APPLICATION NO.	FILING DATE	FIRST NAMED INVENTOR	ATTORNEY DOCKET NO.	CONFIRMATION NO.
10/632,854	08/04/2003	Chung-Kuang Lin	BHT-3118-43	3444
75	90 04/30/2004	·	EXAMINER	
TROXELL LAW OFFICE PLLC			WILKENS, JANET MARIE	
SUITE 1404 5205 LEESBUI	RG PIKE		ART UNIT	PAPER NUMBER
FALLS CHURCH, VA 22041			3637	
			DATE MAILED: 04/30/2004	1

Annlineting Ma	Amplicant/a)				
	Application No.	Applicant(s)	25			
Office Action Summary	10/632,854	LIN ET AL.	- · · · ·			
Office Action Guillinary	Examin r	Art Unit				
Th MAILING DATE of this communication ap	Janet M. Wilkens	3637				
Period for Reply	pears on the cover sheet w	nurur correspond nce addr s	15			
A SHORTENED STATUTORY PERIOD FOR REPI THE MAILING DATE OF THIS COMMUNICATION - Extensions of time may be available under the provisions of 37 CFR 1. after SIX (6) MONTHS from the mailing date of this communication. - If the period for reply specified above, the maximum statutory period - Failure to reply within the set or extended period for reply will, by statu Any reply received by the Office later than three months after the maili earned patent term adjustment. See 37 CFR 1.704(b).	.136(a). In no event, however, may a oly within the statuto

FIG.3

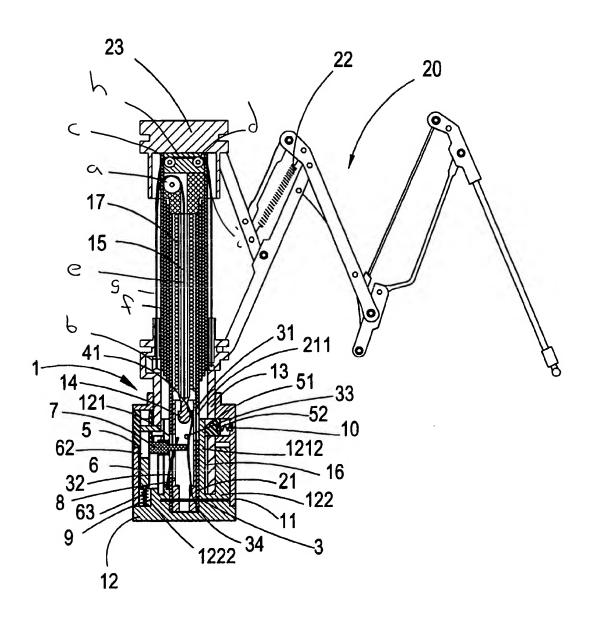
Claim 5 is rejected under 35 U.S.C. 103(a) as being unpatentable over Shih in view of Wu (5,617,889). Shih teaches an automatic umbrella (Fig. 3) comprising: a shaft (2) with a plurality of telescoping tubes, an upper notch (23), a lower runner (13), a rib assembly (20), an opening spring (17), closing springs (22), a control means (in handle 1) with a push button (7) and a locking head (14), first through fourth guiding rollers (a, b, c, and d, respectively; see attachment A), and a rope (15) with five sections (e, f, g, h, i; see Attachment A). For claim 5, Shih fails to teach a control means in the handle with a push button, an upper latch, a lower latch, and a locking head. Wu teaches a control means (in handle 3) with a push button (41), an upper latch (422), a lower latch (430) and a locking head (441). It would have been obvious to one of ordinary skill in the art at the time of the invention to modify the umbrella of Shih by using an alternate type of control means in the handle, i.e. using the mechanism of Wu in place of the mechanism presently used, since these mechanisms are functional

equivalents and it appears that either type of mechanism would work equally well in opening and closing the umbrella of Shih. Some deciding factors on which mechanism to use including economic reasons, personal preferences, etc.
